# Access Compliance Report

## Public Rights-of-Way

### (Curb Ramps)

Intersection ID: 23481	Main Street: ALEXANDER_RD	Cross Street: PROVIDENCE_RD	Location: SE
ADA ID: 09068AFA89AD	Ramp Type: Perp	Initial Pass/Fail: Fail	Overall Compliance: No
Severity Score: 31.25			
Codes/Mitigation Info/Possible Solution		Field Measurements/Component Compliance

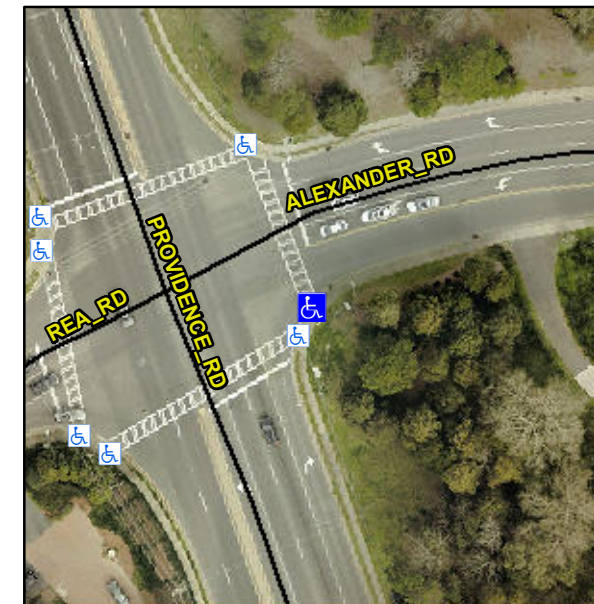
**R304.5.1, R304.2.2, R304.5.3**

Compliance	Description	Data	Compliance	Description	Data
N/A	Ramp Length (in)	71.0	No	Ramp Slope (%)	9.5
No	Ramp Width (in)	32.0	No	Ramp XSlope (%)	3.6
N/A	Flare Type LT	N/A	N/A	Flare Type RT	N/A
N/A	Flare Slope LT (%)	N/A	N/A	Flare Slope RT (%)	N/A
N/A	Flare Traversable LT?	N/A	N/A	Flare Traversable RT?	N/A
N/A	Landing Length (in)	N/A	N/A	DWS Provided?	N/A
N/A	Landing Width (in)	N/A	N/A	DWS Contrast?	N/A
N/A	Landing Slope (%)	N/A	N/A	DWS Length (in)	N/A
N/A	Landing X Slope (%)	N/A	N/A	DWS Full Width?	N/A
N/A	Landing Curb? (Y/N)	N/A	N/A	DWS Offset (in)	N/A
N/A	Shared Landing?	N/A			
N/A	Gutter Ponding?	N/A	N/A	Gutter Slope (%)	N/A
N/A	Gutter Lip Ht (in)	N/A	N/A	Gutter X Slope (%)	N/A
N/A	Painted X Walk1?	Yes	N/A	Painted X Walk2?	N/A
	X Walk 1 Direction	To N		X Walk 2 Direction	N/A
N/A	X Walk 1 Width (in)	85.0	N/A	X Walk 2 Width (in)	N/A
	X Walk 1 Slope (%)	1.5		X Walk 2 Slope (%)	N/A
	X Walk 1 X Slope (%)	1.9		X Walk 2 X Slope (%)	N/A

**Remove & Replace Entire Ramp.**
